**SUBDIVISION REVIEW SHEET****CASE NO.:** C8-2020-0090.0A**ZAP DATE:** July 21, 2020**SUBDIVISION NAME:** Menchaca Road Apartments**ADDRESS:** 7731 Menchaca Road**APPLICANT:** CRP-GREP Elan Dawson Owner L.P. (Logan Kimble, Greystar)**AGENT:** BGE, Inc. (Brian Grace, P.E.)**ZONING:** GO-MU**NEIGHBORHOOD PLAN:** N/A**AREA:** 10.70 acres**LOTS:** 1**COUNTY:** Travis**DISTRICT:** 5**WATERSHED:** South Boggy Creek**JURISDICTION:** Full Purpose**SIDEWALKS:** Sidewalks will be constructed along Menchaca Rd.**VARIANCES:** One variance request to LDC 25-4-34, Balance of Tract.**DEPARTMENT COMMENTS:**

**EXHIBIT D**CITY OF AUSTIN –DEVELOPMENT SERVICES DEPARTMENT  
SUBDIVISION APPLICATION – MASTER COMMENT REPORT

CASE NUMBER: C8-2020-0090.0A  
 REVISION #: 00  
 CASE MANAGER: Jennifer Bennett-Reumuth  
 UPDATE: U0  
 PHONE #: 512-974-9002

PROJECT NAME: Menchaca Rd Apartments  
 LOCATION: 3707 MENCHACA RD

DEED EXHIBIT  
WITH CURRENT  
T.C.A.D. PARCELS OVERLAID

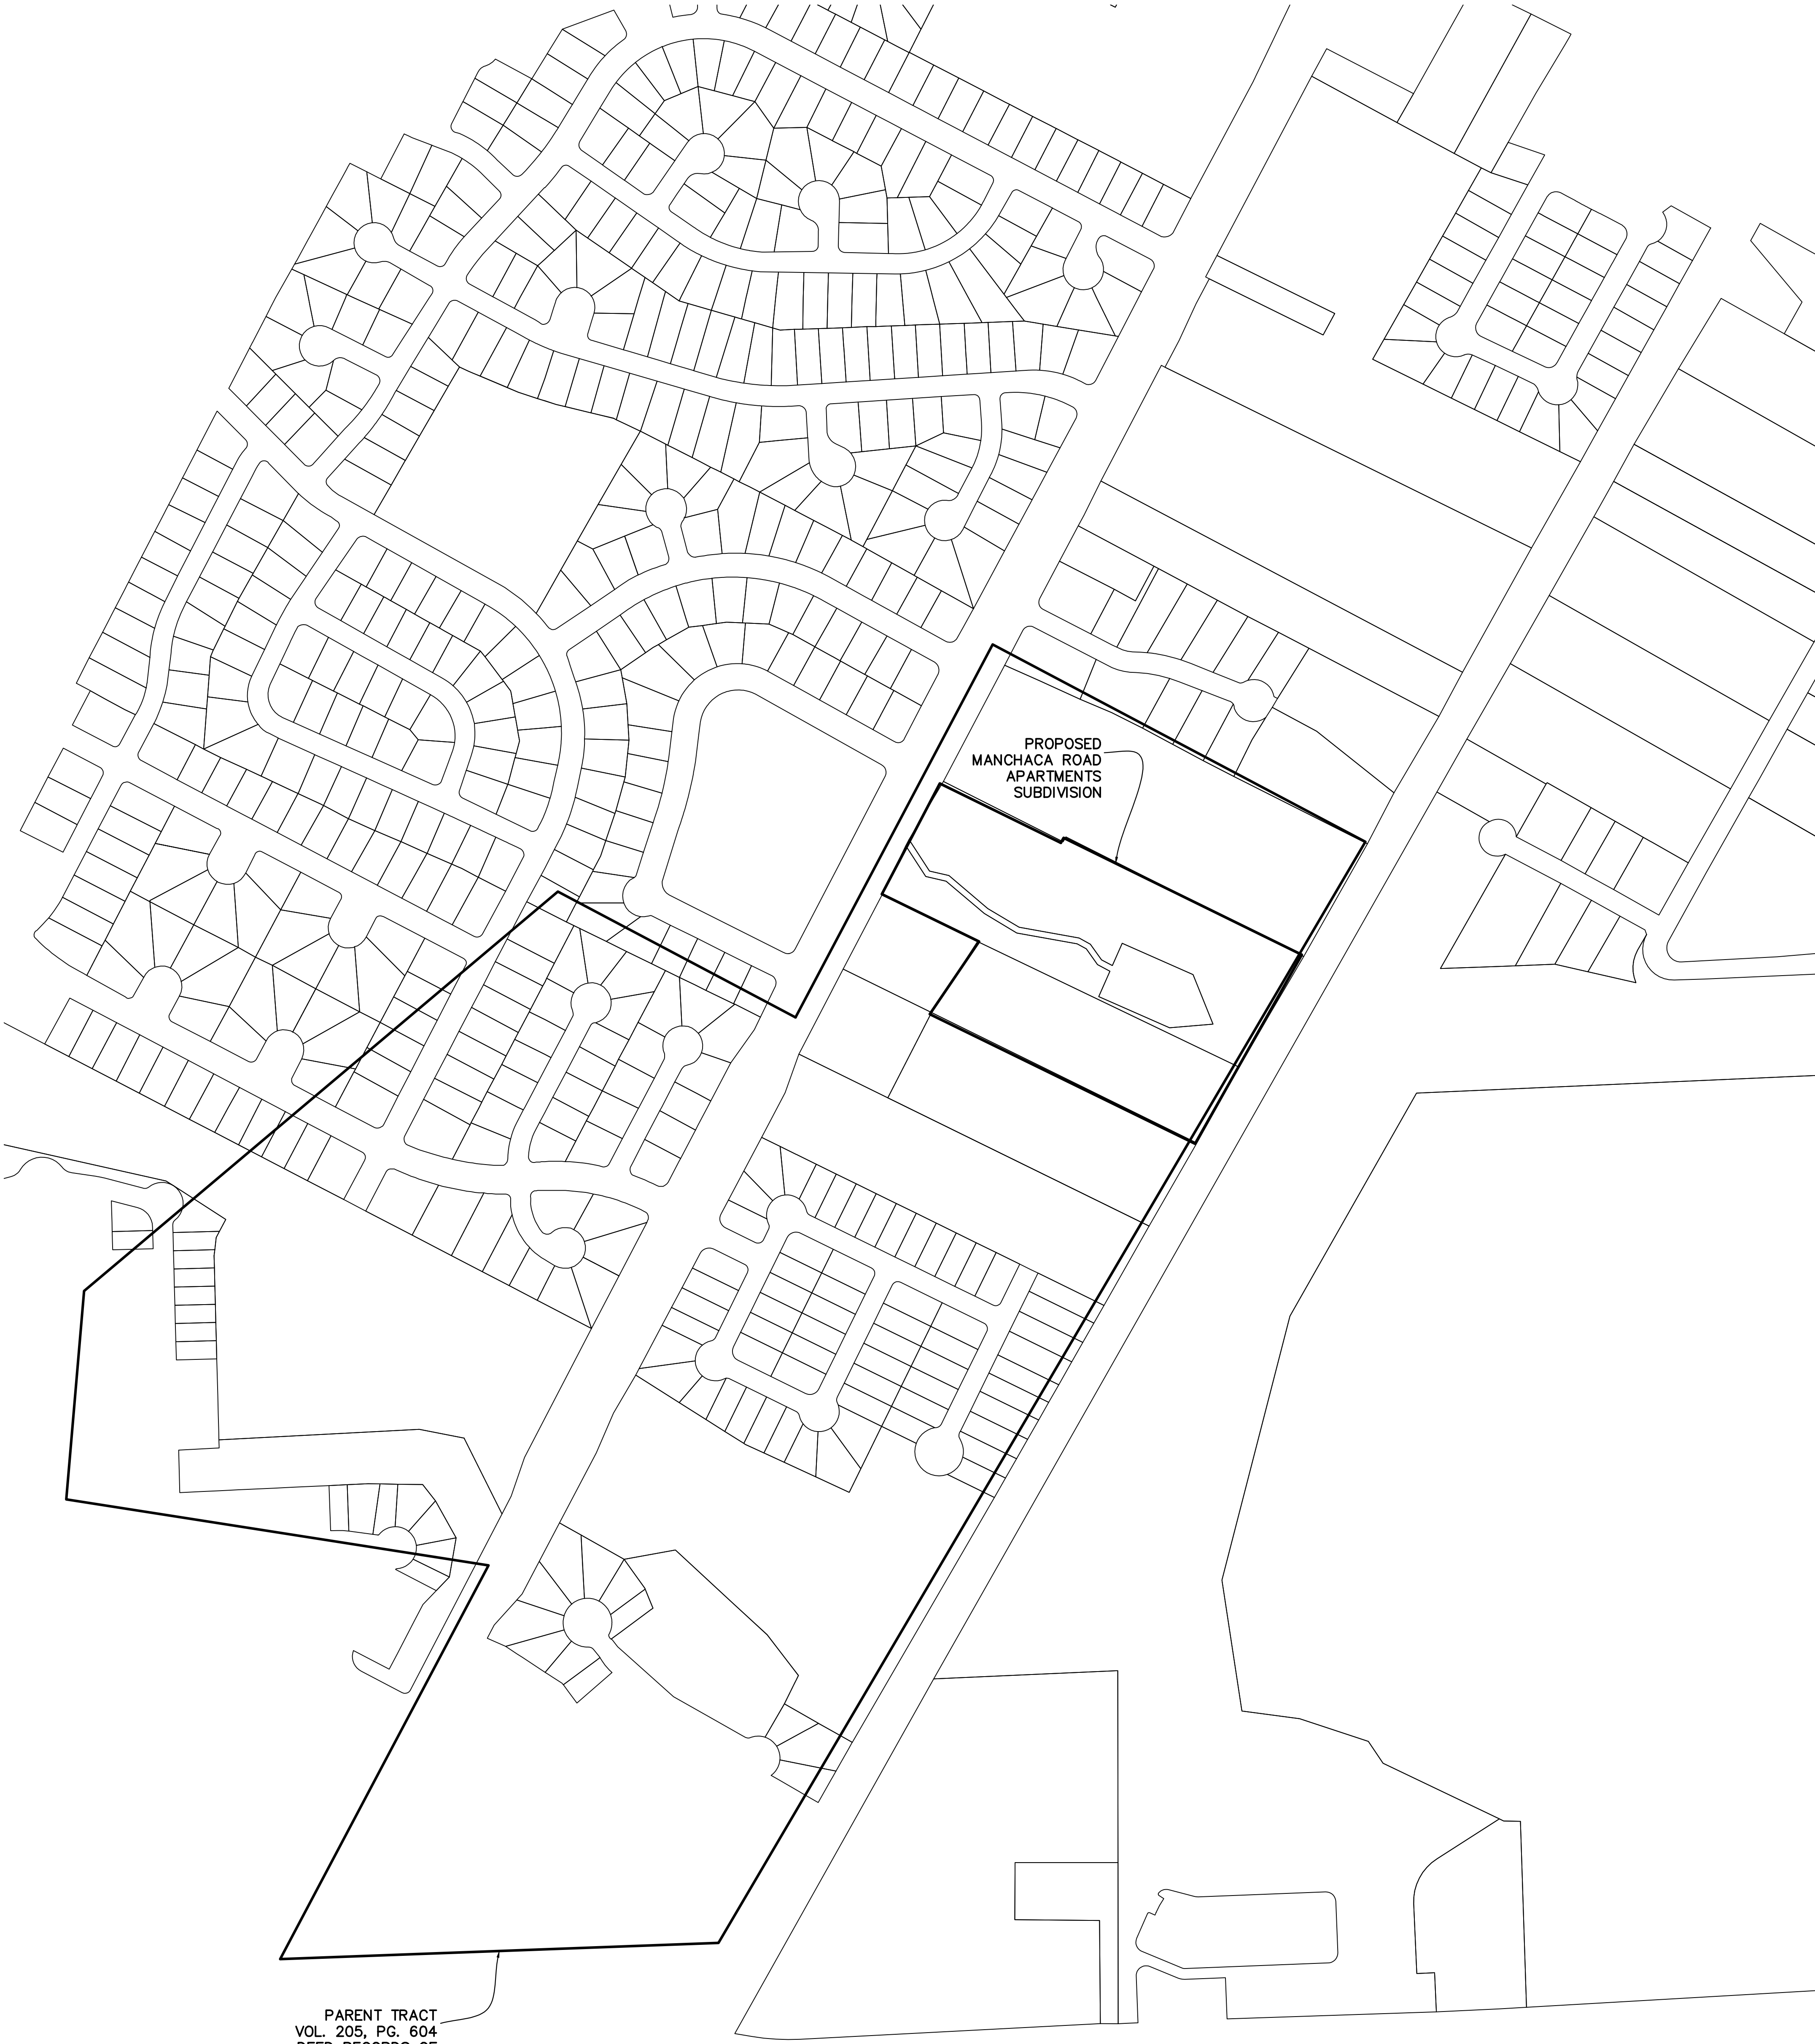
This letter is to formally request a variance from 25-4-34 of the Land Development Code which requires an application for a final plat to include all land constituting the original tract. The property has not existed in its current configuration prior to the date which it became subject to the City's jurisdiction over subdivision of the land. This requirement imposes an unreasonable hardship on the applicant as the original tract dates back to 1907 and was 107 acres in size. It would be impractical for the applicant to track down all potential property owners to include them in the plat, as many lots from the original tract have already been platted and developed. An exhibit is included which shows the approximate limits of the original tracts overlaid on current TCAD parcels to outline how the original tract does not exist in its current form.

Subdividing only a portion of the original tract would not substantially impair the planning on roads or other public facilities as the property is located within a near fully developed portion of the City. There are no proposed roadway facilities per the latest ASMP that cross through any portion of the original tract.

The nearest adjacent tracts to the site which are part of the original tract and unplatted are may still be reasonably used for development. A summary is below:

TCAD 0422150116 – 1.25 acres with direct frontage (greater than 50' wide) to Menchaca Road  
TCAD 0422150114 – 1.32 acres with direct frontage (greater than 50' wide) to Menchaca Road  
TCAD 0422150115 & TCAD 0422150113 – 3.93 acres & 4.89 acres. These tracts are listed together as they are both owned by "Last Rock Star LLC". The 3.93 acre tract does not have frontage to Menchaca Road, however, the 4.89 acre does have greater than 50' of frontage to Menchaca Road. This gives the property owner the ability to reasonably use and develop the properties.
